**6.5** **60 - 82 JOHNSON STREET, SOUTH MELBOURNE**  
**LOCATION/ADDRESS:** **60 - 82 JOHNSON STREET, SOUTH MELBOURNE**  
**EXECUTIVE MEMBER:** **LILI ROSIC, GENERAL MANAGER, CITY STRATEGY AND SUSTAINABLE DEVELOPMENT**  
**HELEN PRITCHARD, FBURA PLANNER**  
**PREPARED BY:** **SIMON GUTTERIDGE, PLANNING COORDINATOR CANAL WARD AND FISHERMANS BEND**

- 1.1 To consider an amendment to Ministerial planning permit MPA14/0003-1 and determine Council's position on the proposed changes, in response to a Ministerial Referral in the Fishermans Bend Urban Renewal Area.

<b>WARD:</b>	Gateway
<b>TRIGGER FOR DETERMINATION BY COMMITTEE:</b>	Accommodation (dwellings) within the Fishermans Bend Urban Renewal Area
<b>APPLICATION NO:</b>	9/2013/MIN/A
<b>APPLICANT:</b>	SALVO PG Pty Ltd
<b>EXISTING USE:</b>	Warehouse
<b>ABUTTING USES:</b>	Light industrial
<b>ZONING:</b>	Capital City Zone (CCZ1)
<b>OVERLAYS:</b>	Parking Overlay (PO1) Design & Development Overlay (DDO32) Special Building Overlay (SBO2) Environmental Audit Overlay (EAO) Infrastructure Contributions Overlay (ICO)
<b>STATUTORY TIME REMAINING FOR DECISION AS AT DAY OF COUNCIL</b>	N/A

**Former proposal – significant green areas, including the next level over.**

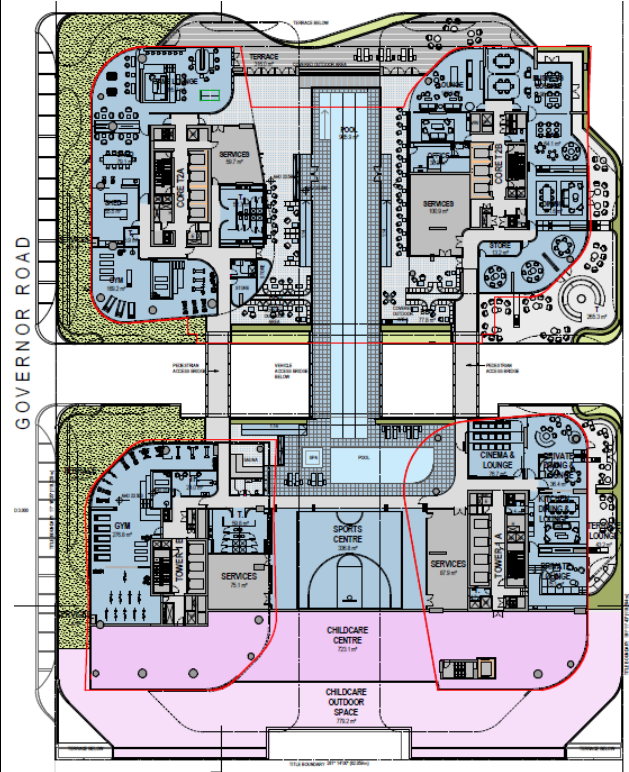
*The changes proposed to the development would see a drastic reduction in landscaping of the podium levels. The approved scheme indicates that the entire podium top-levels are to be landscaped as noted on Level 6 and 7 floor plans, however the proposed plans only indicate a small portion of this.*

*The changes proposed are not supported without these elements being adequately addressed.*

**Current proposal – shows a substantially reduced landscaped area with no greening shown on the level over.**

Therefore, in order to ensure that the storm water management and urban heat island reduction features of this development aren't diminished, a condition is recommended to require the introduction of green walls and roofs elsewhere on the plans, to provide an equal or greater extent of coverage.
